SUBJECT: **Addendum #3 – I-15 La Mesa Nisqualli Interchange Project, San Bernardino County, in the City of Victorville, California, and SANBAG Contract No. C12010**

Addendum No. 3 is hereby issued to the following documents for I-15 La Mesa Nisqualli Interchange project in San Bernardino County, in the City of Victorville, California.

LA MESA ROAD/NISQUALLI ROAD OC

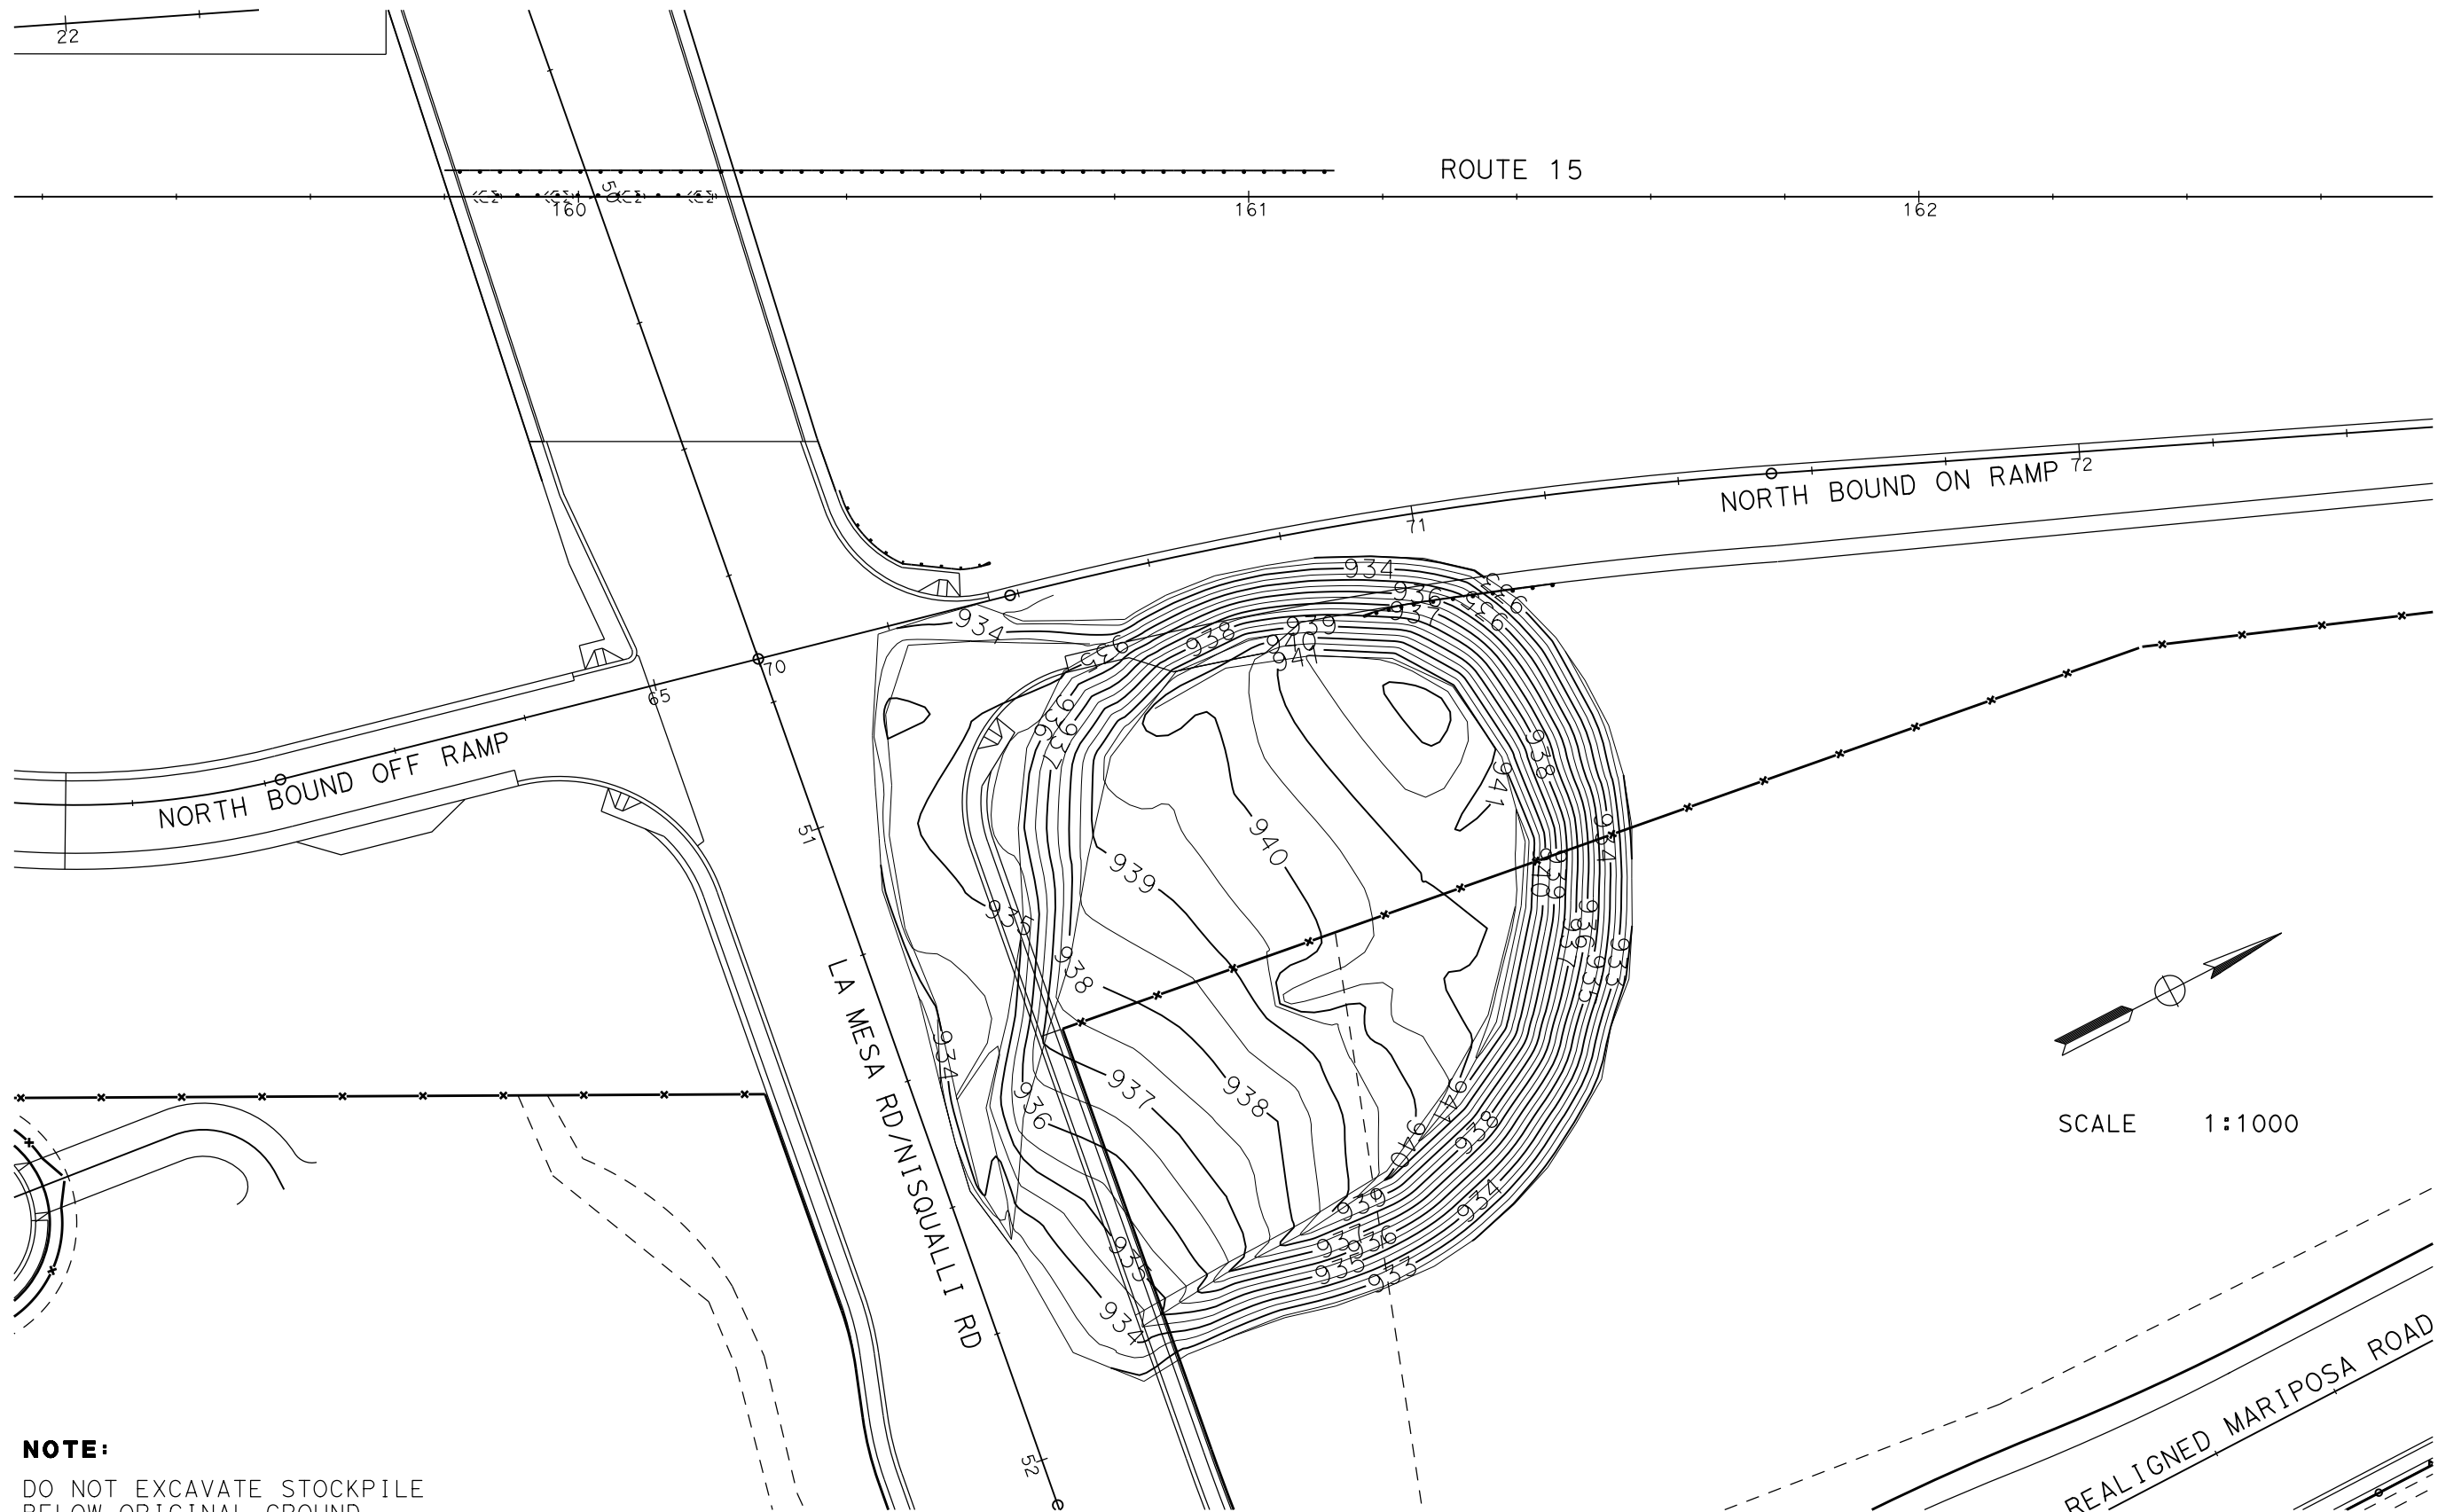
7. In Plan Set A, Add Addendum # 3, Exhibits 1, 2 and 3 “Existing Stockpile Locations”. Existing stockpiles are provided as “Local Borrow”. These exhibits depict corrected contours of existing ground compared to the surface levels reflected in the plan sheet contours. Local Borrow sites include “Oversized Rubble”

27. Question: Is it allowable to bury, within the embankment, the existing rubble consisting of broken AC and Concrete located at the SW corner of La Mesa/Amargosa Road?

1. As noted in **revised Table on Sheet Q-1 (Addendum # 3)** in the Bid documents, Agency has stockpiled approximately **87,300 m³** of soil material at various locations within the project site. Locations are visible on the site. A sketch showing the location of the dirt stockpiles is provided in provided in **Addendum # 3**. Stockpiled material includes broken concrete and asphalt.

Response: See Material Handout – Addendum # 3. Oversize rubble cannot be buried on site.

Figure 3-18 Calibration Diurnal Curves for Weekdays and Weekends at W46-105

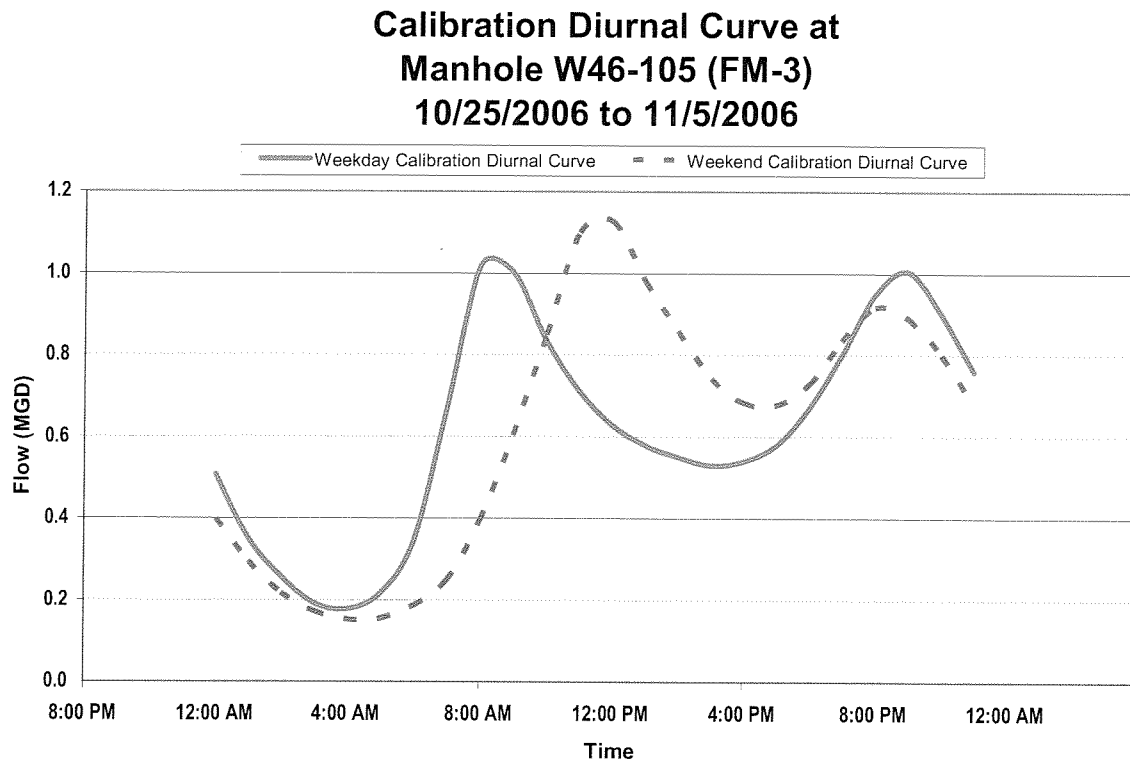
14. Question: On Sewer Improvements Sheet 9 of 10, what is the current max flow of existing 15" sewer line that we have to tie into? What are the sewer by-pass requirements?

Response: See enclosed flow data (Earth Tech Inc sheet 6 dated September 2006, sheet 63 dated August 2008, and sheet 64 dated August 2008). City will require sewer to be in service throughout the project. Sewer By pass requirements per Book 3 of 3.
